MITIGATION PLAN

**Sandy Bridge Farm Restoration Site
Rutherford County, North Carolina
DMS Contract 6400
DMS Project Number 96920**

Re: NCIRT Review and USACE Approval of the Sandy Bridge Mitigation Plan;
SAW-2015-00827; DMS Project #96920

SUBJECT: Sandy Bridge Farm Restoration Site - NCIRT Comments During 30-day Mitigation Plan Review

WATER QUALITY TREATMENT AREA
SCALE: NTS

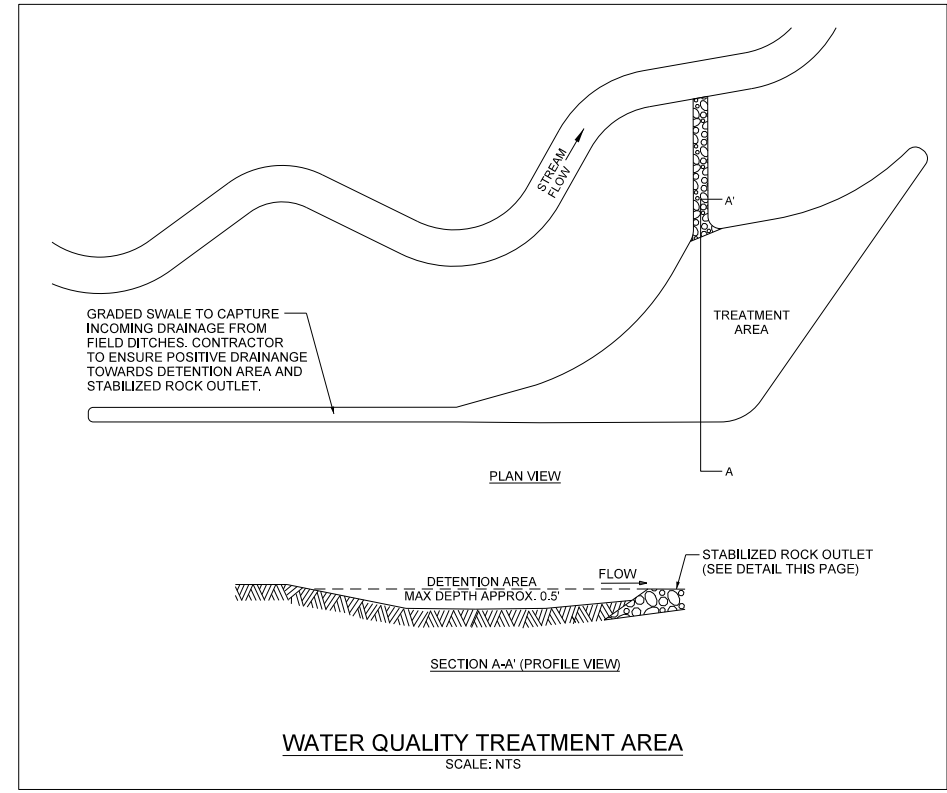
5. Page 1: The Water Quality Treatment Area shown on page 162 and 163 (Site Plans) is not mentioned in the document and should be included (or removed from site plans) as one of the objectives addressing the goal of protecting and improving water quality leaving the site.

5. Page 1: The Water Quality Treatment Area shown on page 162 and 163 (Site Plans) is not mentioned in the document and should be included (or removed from site plans) as one of the objectives addressing the goal of protecting and improving water quality leaving the site.
We will add a description of the Water Quality Treatment Area in to Section 7.2. However, we view this feature as more of an ancillary treatment for a small portion of incoming stormwater and less of an integrated project component with measureable outcomes.
